Access Compliance Report

Public Rights-of-Way

(Curb Ramps)

Intersection ID: 29286	Main Street: FAR_WEST_DR	Cross Street: TULLOCK_CREEK_DR	Location:	N
ADA ID: 22E354FEA762	Ramp Type: PerpDiag	Initial Pass/Fail: Fail	Overall Compliance: No	Severity Score: 18.75

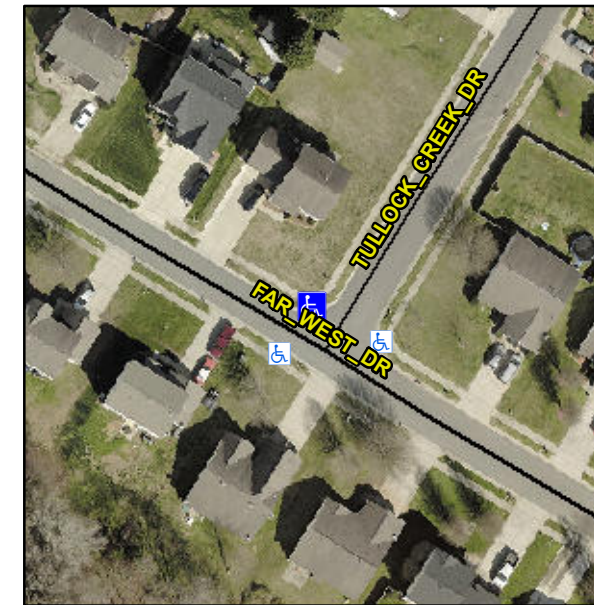
Not Found, R304.5.1, R304.5.3

Compliance	Description	Data	Compliance	Description	Data
N/A	Ramp Length (in)	48.0	Yes	Ramp Slope (%)	6.0
No	Ramp Width (in)	32.0	No	Ramp XSlope (%)	2.6
N/A	Flare Type LT	N/A	N/A	Flare Type RT	N/A
N/A	Flare Slope LT (%)	N/A	N/A	Flare Slope RT (%)	N/A
N/A	Flare Traversable LT?	N/A	N/A	Flare Traversable RT?	N/A
N/A	Landing Length (in)	N/A	N/A	DWS Provided?	N/A
N/A	Landing Width (in)	N/A	N/A	DWS Contrast?	N/A
N/A	Landing Slope (%)	N/A	N/A	DWS Length (in)	N/A
N/A	Landing X Slope (%)	N/A	N/A	DWS Full Width?	N/A
N/A	Landing Curb? (Y/N)	N/A	N/A	DWS Offset (in)	N/A
N/A	Shared Landing?	N/A			
N/A	Gutter Ponding?	N/A	N/A	Gutter Slope (%)	N/A
N/A	Gutter Lip Ht (in)	0.75	N/A	Gutter X Slope (%)	N/A
N/A	Painted X Walk1?	No	N/A	Painted X Walk2?	No
	X Walk 1 Direction	To W		X Walk 2 Direction	To E
N/A	X Walk 1 Width (in)	N/A	N/A	X Walk 2 Width (in)	N/A
	X Walk 1 Slope (%)	2.4		X Walk 2 Slope (%)	5.8
	X Walk 1 X Slope (%)	3.0		X Walk 2 X Slope (%)	0.2

Remove & Replace Curb Ramp With Two New Directional Ramps or Equivalent.
